Real Property Data Search

P & Z File No. F-83-03

RE: F-82-83

OLD HACIENDA

Top Map of

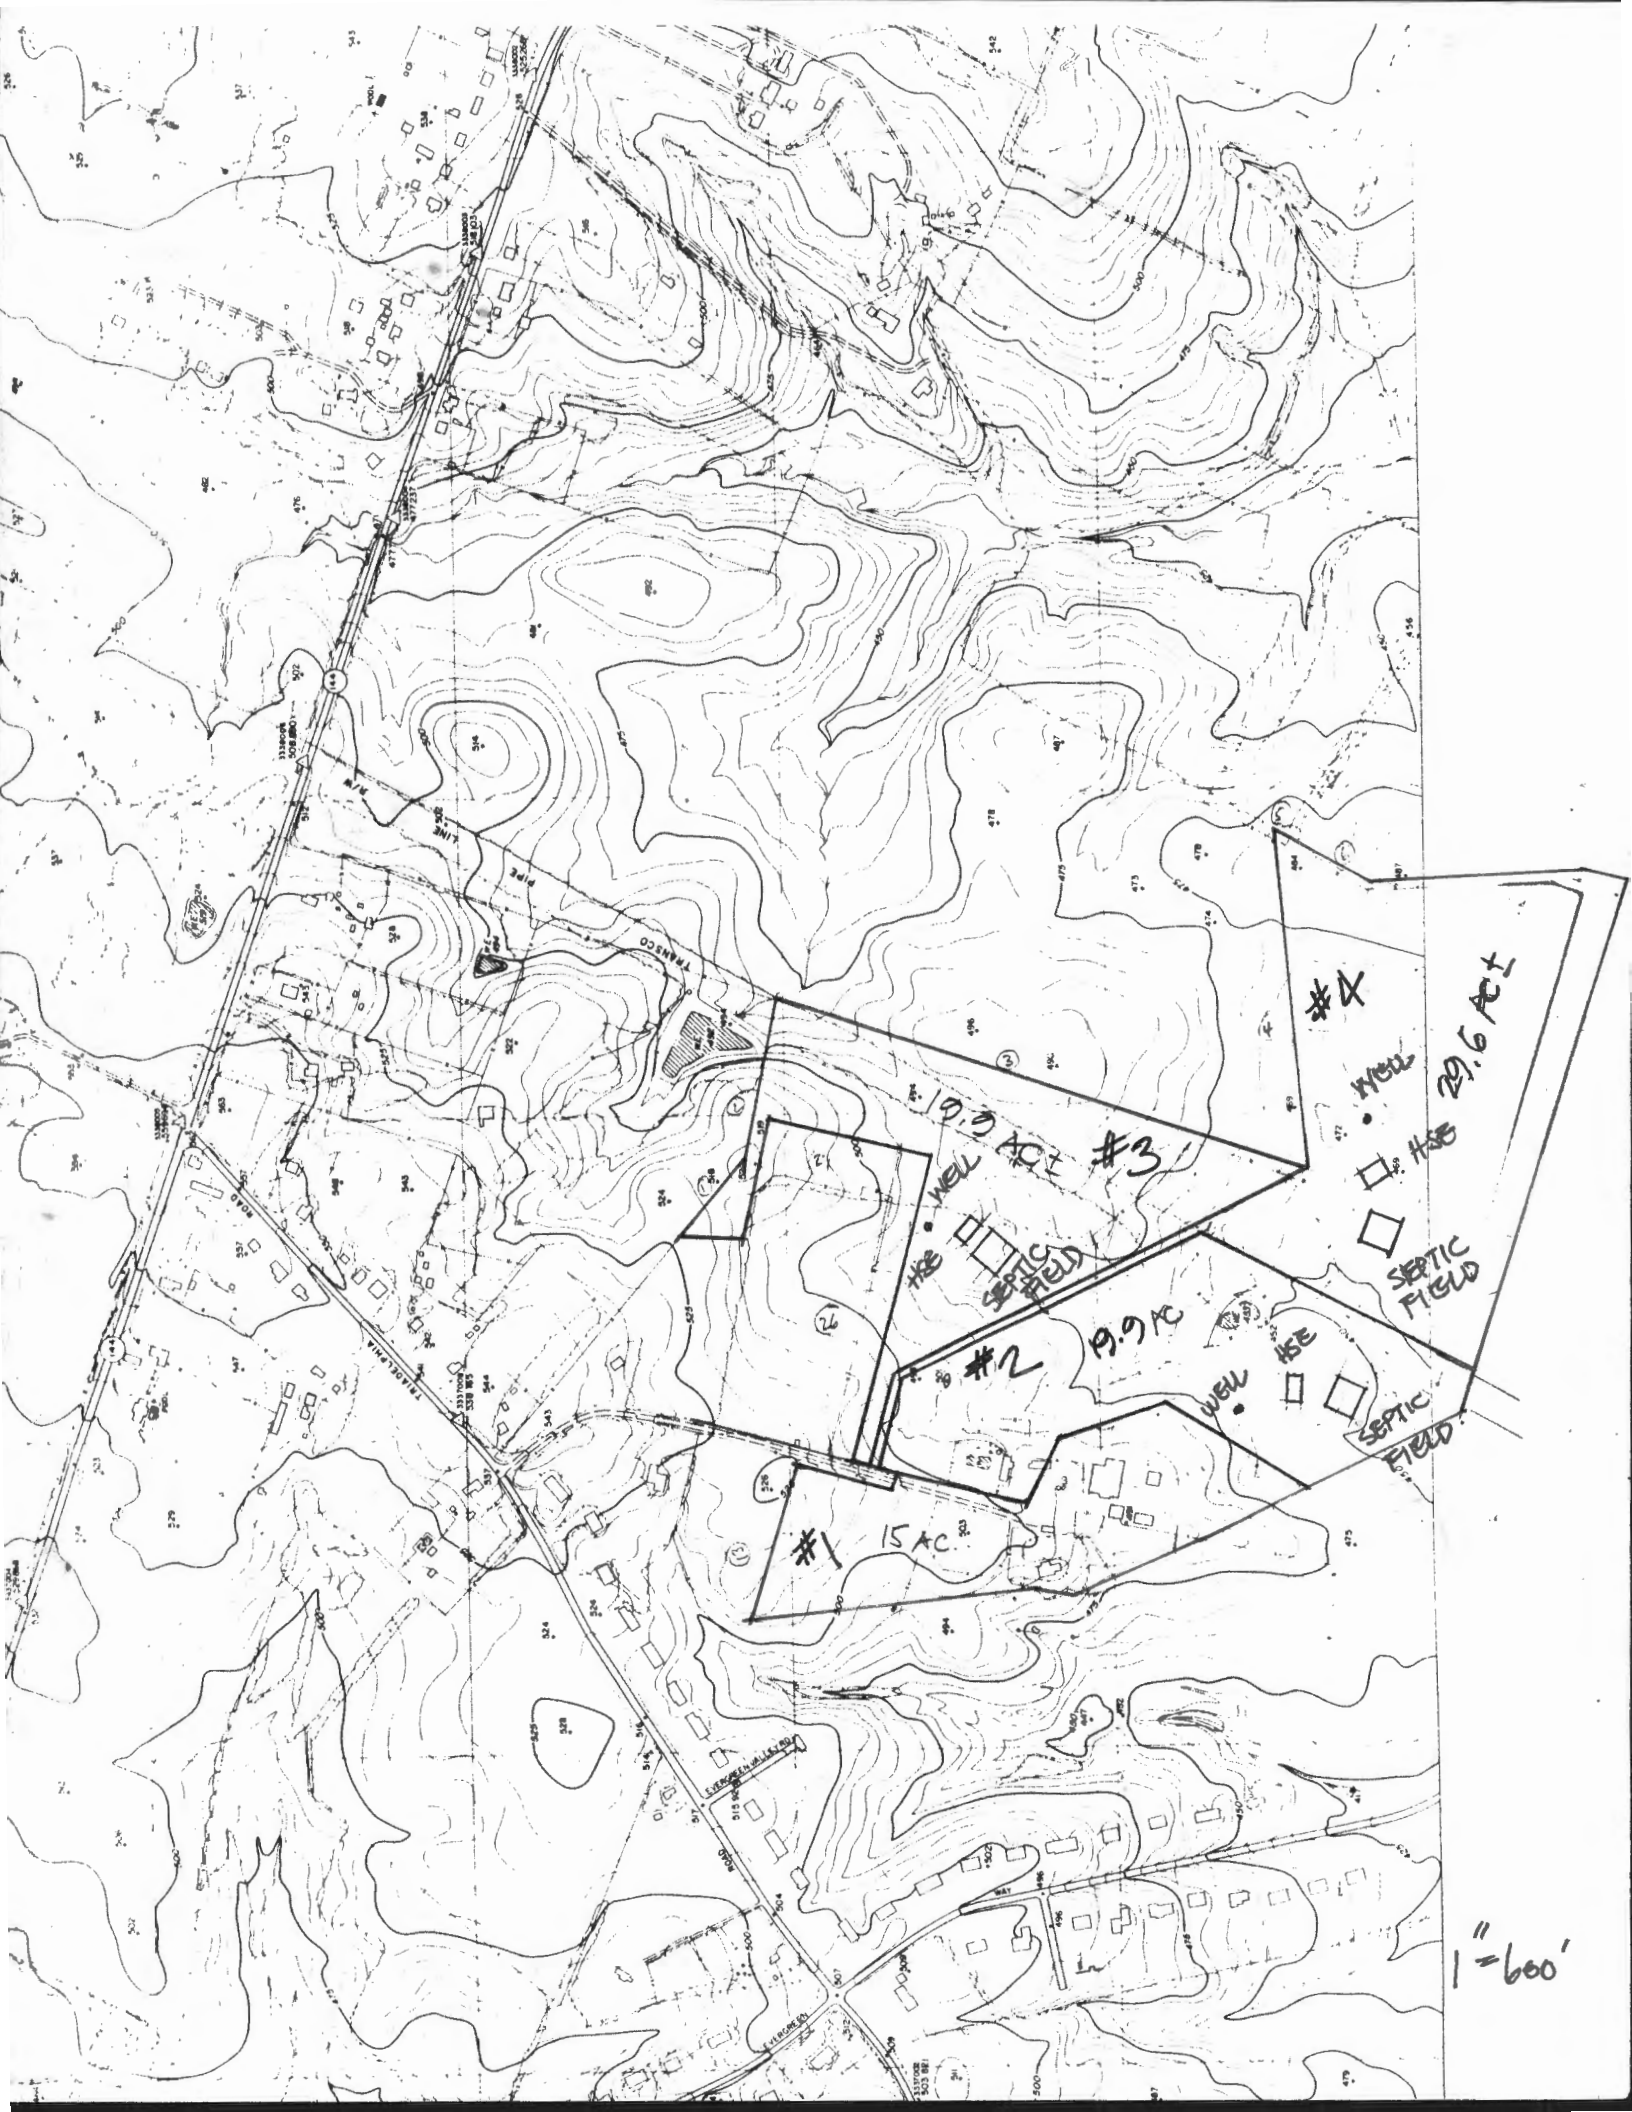
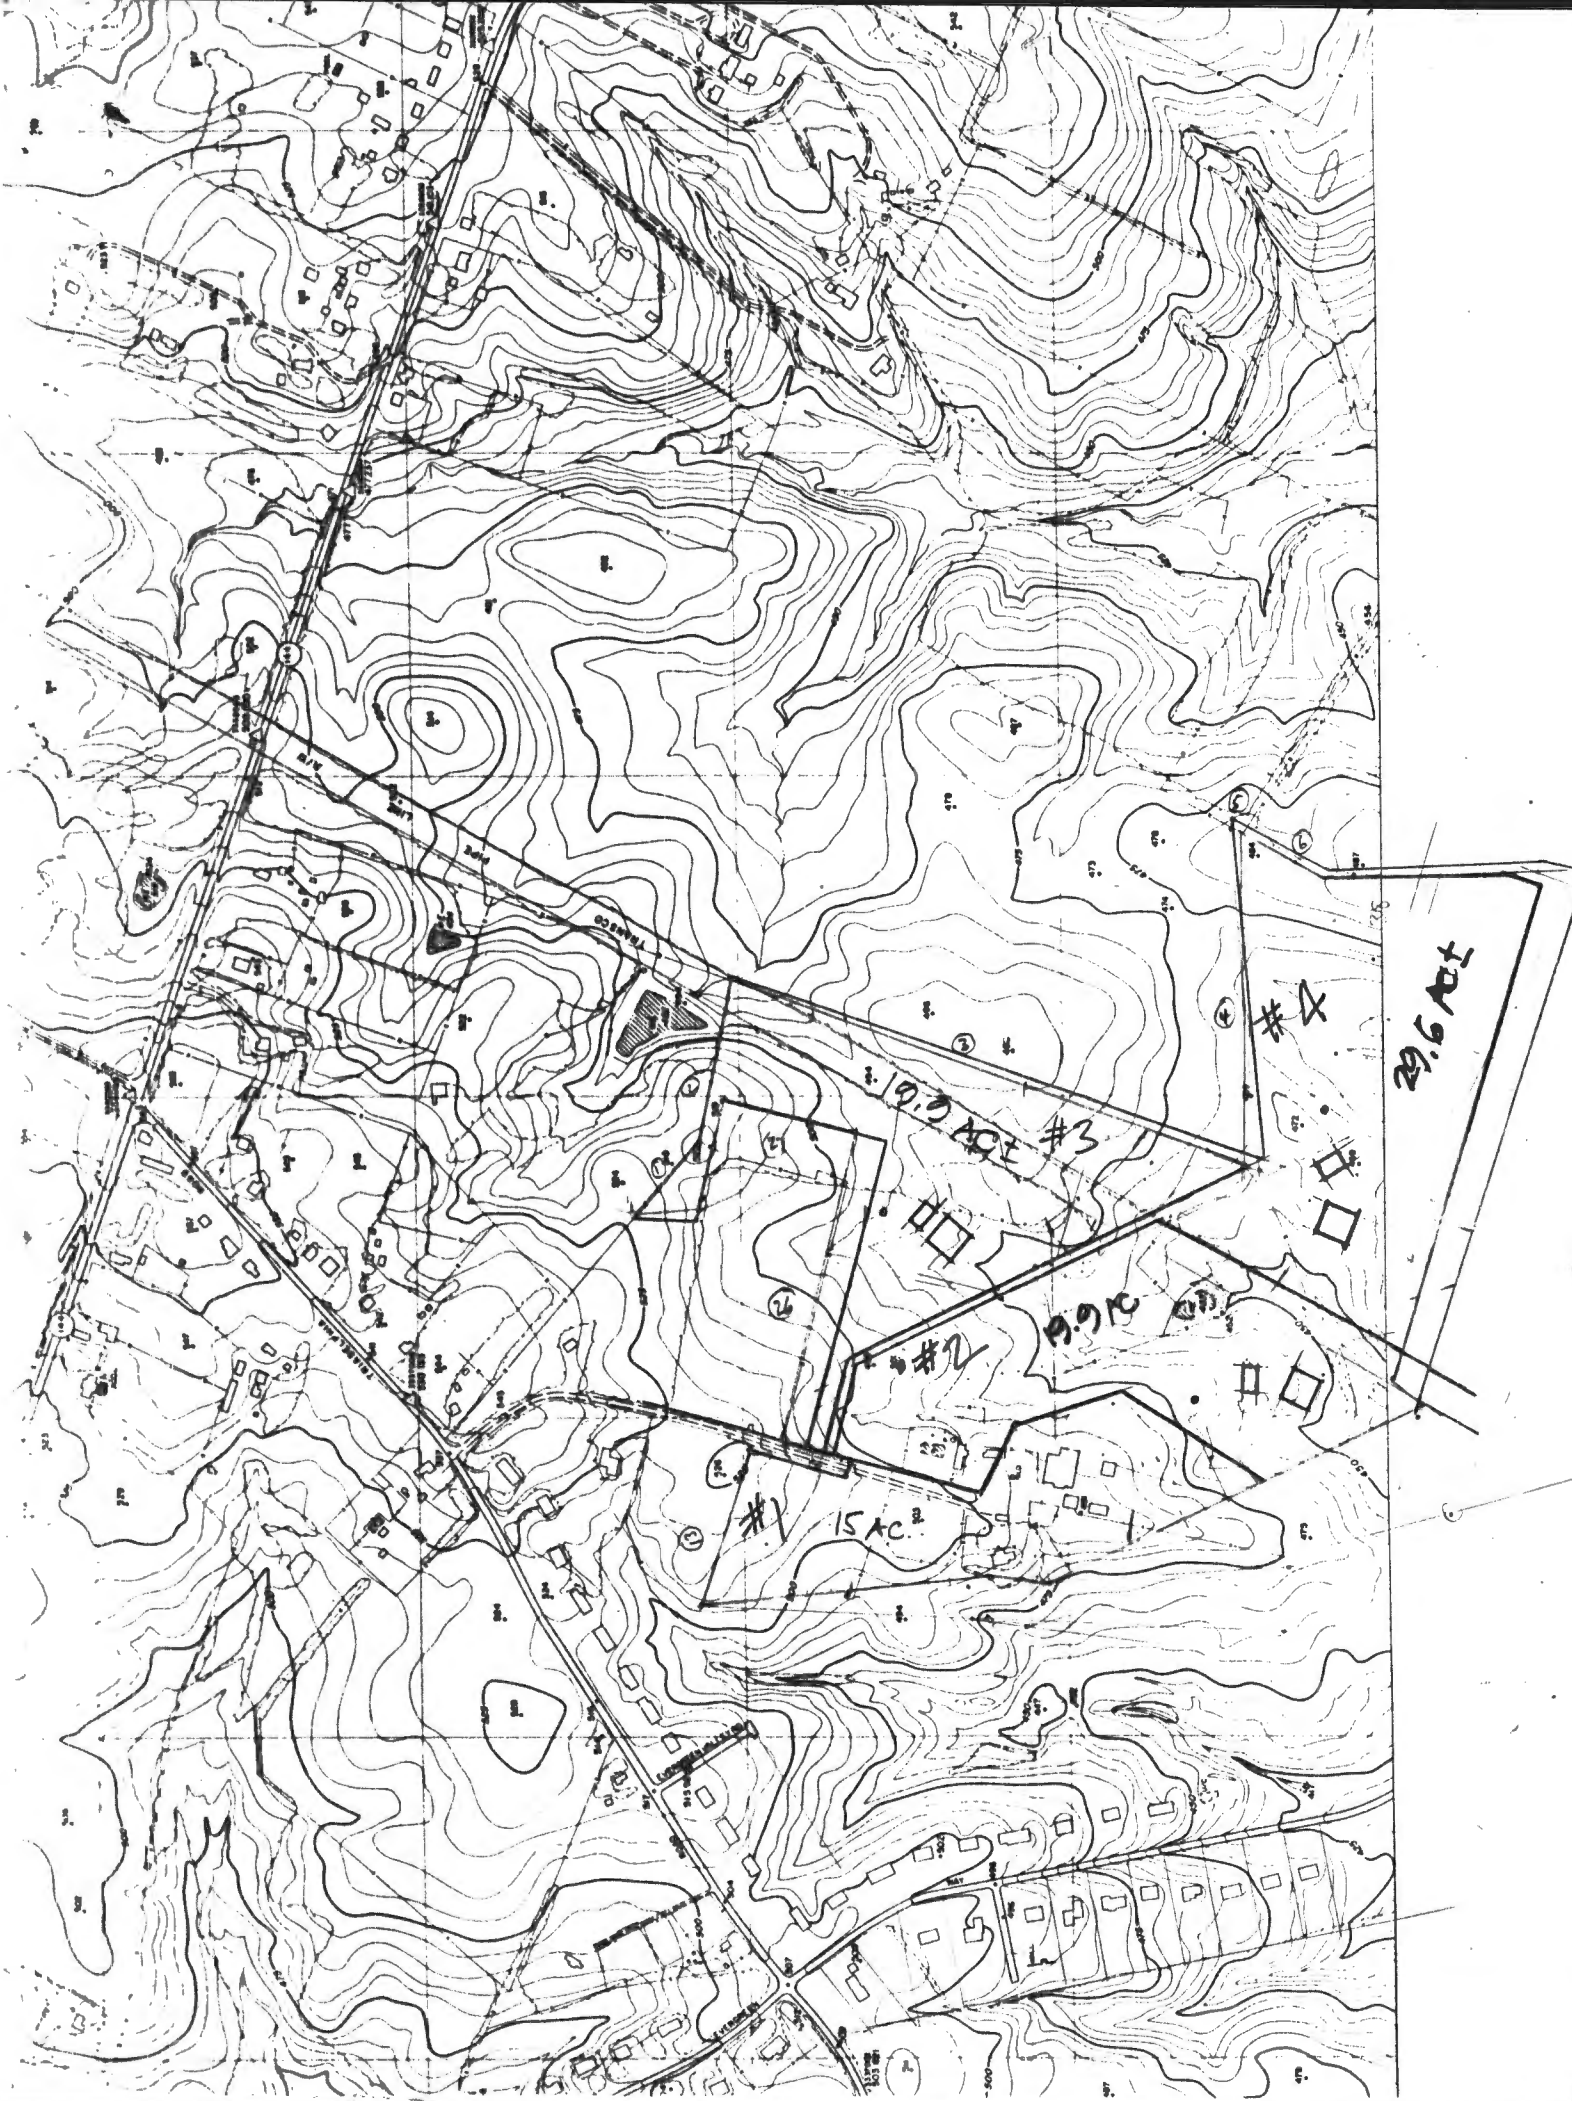
COMMENTS: Aug 3-10-82

SEE ATTACHED COMMENTS

1. THE LOTS SHOULD HEREBY COMPLY WITH THE MINIMUM OVERSEERSHIP WIDTH AND LOT AREA AS REQUIRED BY THE MARYLAND STATE DEPARTMENT OF HEALTH AND MENTAL HYGIENE.

2. THIS AREA DESIGNATES A PRIVATE SEWAGE EASEMENT OF 10,000 sq. ft. AS REQUIRED BY THE MARYLAND STATE DEPARTMENT OF HEALTH AND MENTAL HYGIENE FOR INDIVIDUAL SEWAGE DISPOSAL IMPROVEMENTS OF ANY NATURE IN THIS AREA ARE RESTRICTED UNTIL PUBLIC SERVICE IS AVAILABLE. THESE EASEMENTS SHALL BECOME NULL & VOID UPON CONNECTION TO A PUBLIC SEWAGE SYSTEM. THE COUNTY HEALTH OFFICER SHALL HAVE THE AUTHORITY TO SUEUT VANDAUCEY FOR DELINQUENCY IN THIS MATTER. THE PRIVATE SEWAGE ESMT. RECORDATION OF A 10,001 SQ. FT. SEWAGE ESMT. SHALL NOT BE NECESSARY.
3. EXISTING STRUCTURE ON LOT 1
